# UNITED STATES PATENT AND TRADEMARK OFFICE

APPLICATION NO.	FILING DATE	FIRST NAMED INVENTOR	ATTORNEY DOCKET NO.	CONFIRMATION NO.
10/786,725	02/25/2004	Kirk D. Swenson	3896-031736 (P-6004)	2750
32182 7.	590 10/11/2006	EXAMINER		
DAVID W. HIGHET, VP AND CHIEF IP COUNSEL BECTON DICKINSON AND COMPANY [THE WEBB LAW FIRM] FRANKLIN LAKES, NJ 07414-1880			TOWA, RENE T	
			ART UNIT	PAPER NUMBER
			3736

#### **DETAILED ACTION**

1. This Office action is responsive to an amendment filed July 20, 2006. Claims 1-9 and 23-26 are pending. Claims 10-22 and 27-38 have been cancelled. No claim has been added. Claim 1 has been amended.

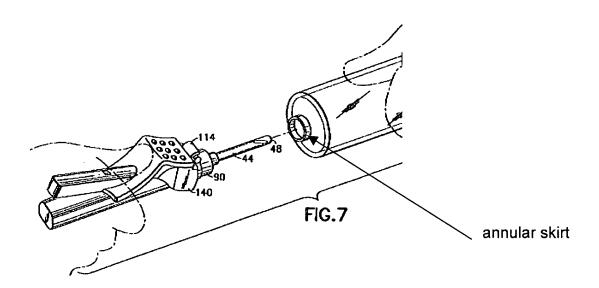
9. Applicant's arguments filed July 20, 2006 have been fully considered but they are not persuasive. Applicant argues that Newby et al. (hereinafter Newby) fails to disclose a device wherein a safety shield and a collar can be radially rotated to a desired position

around the axis without the axial movement of the collar along the axis. This argument has been considered and has not been deemed persuasive.

In regards to the Applicant's argument that Newby fails to teach to disclose a device wherein a safety shield and a collar can be radially rotated to a desired position around the axis without the axial movement of the collar along the axis, the Examiner respectfully disagrees. As better depicted in figure 7, Newby discloses a device that comprises an annular skirt attached to the housing and a safety shield and a collar can be radially rotated to a desired position around the axis without the axial movement of the collar along the axis (see illustration below, see rejections supra).
